From: Kevin Solie [KSolie@bec.com]
Sent: Monday, July 06, 2009 3:14 PM
To: Lein, Jerry R.
Subject: Basin Electric Belfield to Rhame structure move request
Attachments: Area_5.pdf; 181-090-T3-026.pdf

Basin Electric is requesting changes in the locations for two structures in Section 14, T132N, R101W on the Belfield to Rhame 230kV transmission line.

47 **PU-07-169** Filed: 7/6/2009 Pages: 3
Email Requesting Changes in Structure Locations + Map

Overview

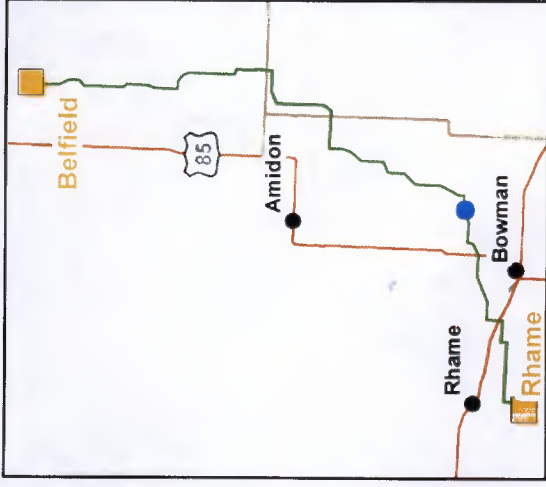
The proposed changes are along the permitted centerline alignment. Structure 159 would move approximately 70 feet SW and structure 160 would move approximately 30 feet SW.

An archeological survey was done on the original route. Metcalf performed the archeological survey on the revised route and a cultural site was found about 30 feet from the proposed location for structure 159. To provide additional clearance, Basin Electric proposes to move the structure location 70 feet to the southwest along the approved centerline. This move required the adjacent structure 160 to be moved 30 feet in the same direction. A diagram and revised plan and profile drawings are attached.
